Comments on the Colstrip Stage I and II Evaporation Ponds Report

July 24, 2013

Geo-Hydro, Inc (GHI) has reviewed the Stage I and II Evaporation Ponds Report that was prepared for PPL Montana, LLC by Hydrometrics, Inc., dated May 2013. Our specific comments and observations are referenced to sections of that report although many of the comments are in fact applicable to multiple sections.

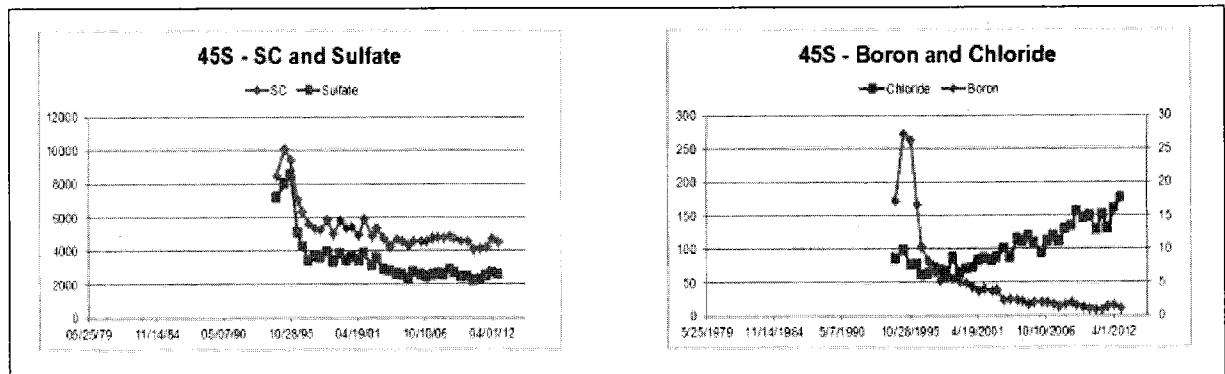
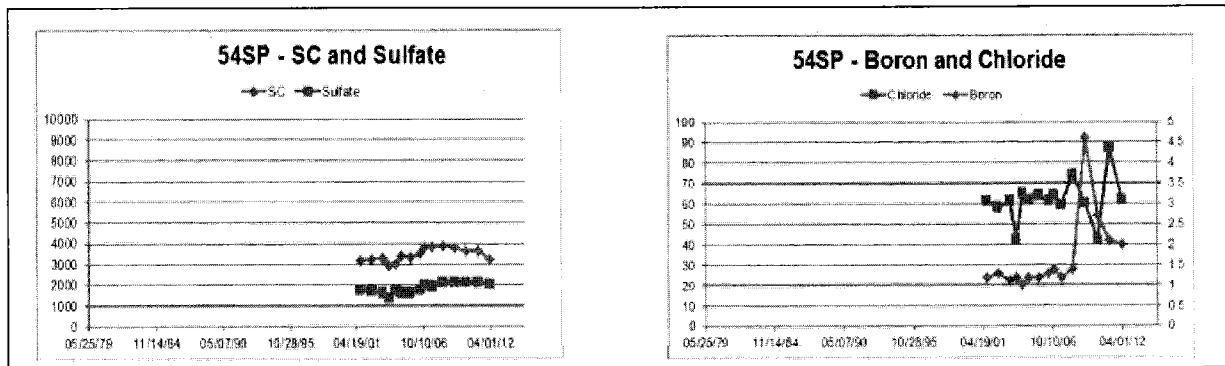
The data show that along with bromide; boron, specific conductance and sulfate are all very high. All of these wells are clearly impacted by process water with wells 922A and 924A showing higher impacts than well 2019D. Current seepage from the ponds is therefore likely.

Note: Graphs reproduced from Colstrip 2012 Plant Site Report

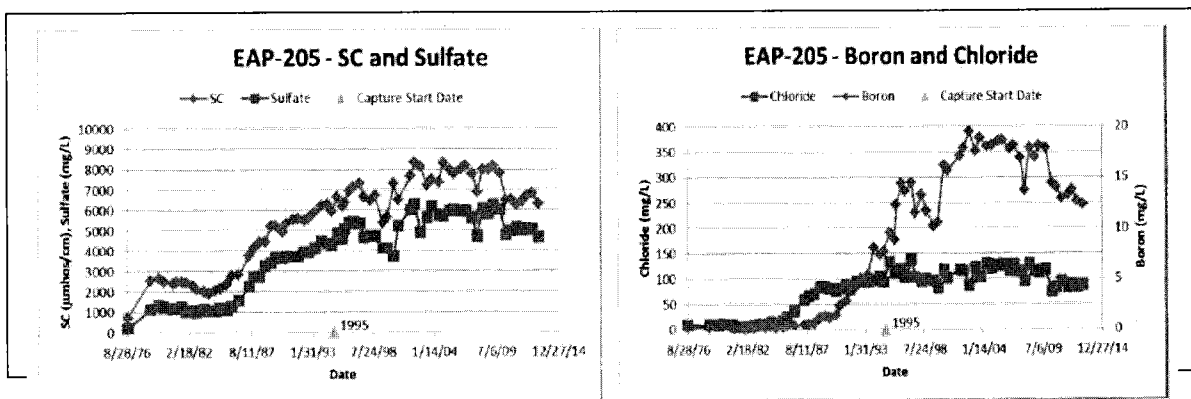
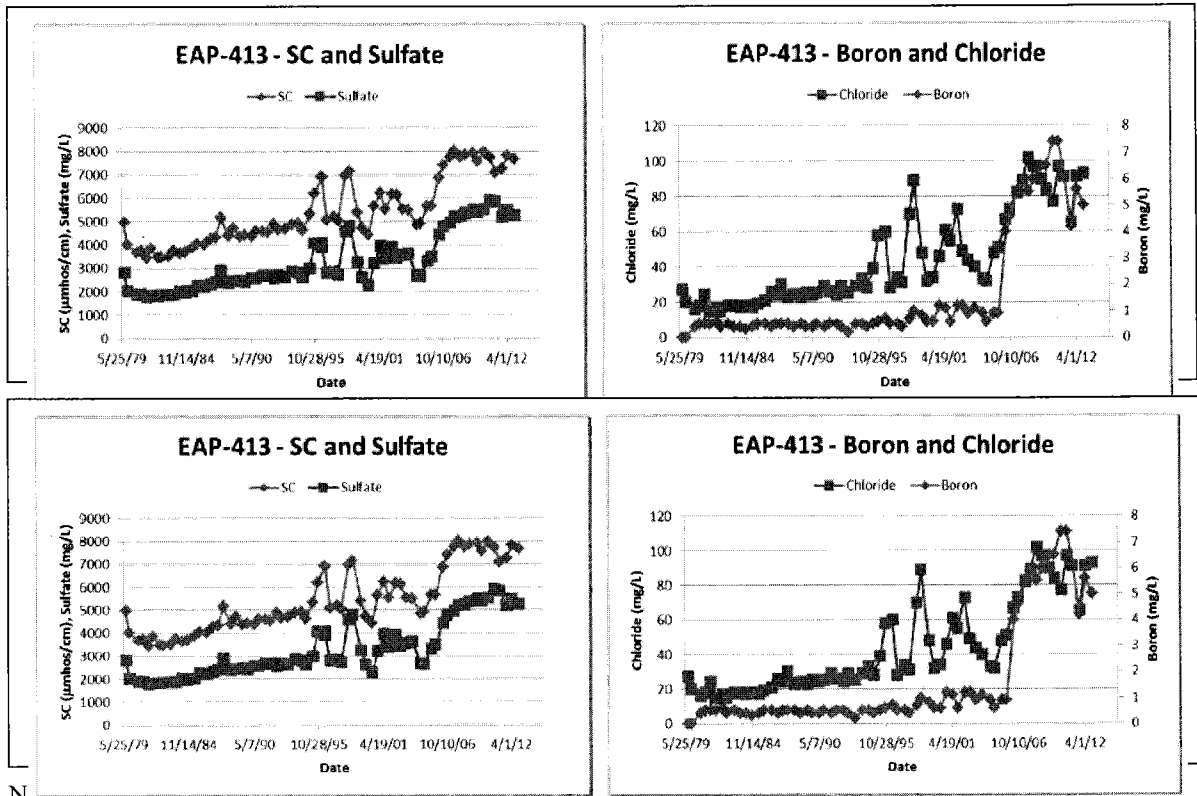
9. **Page 3-60, Section 3.6, Effectiveness Assessment of Remedial Action** – The evaluation of remediation effectiveness is based on evaluation of specific conductance rather than evaluating the full suite of indicator parameters. Review of analytical data plots from other plant areas (examples shown below) show many instances where other parameters such as boron, sulfate, or chloride have increased concurrent with steady or declining specific conductance. The specific conductance measured at an extraction well is therefore not necessarily reflective of overall groundwater quality, even at a specific well.
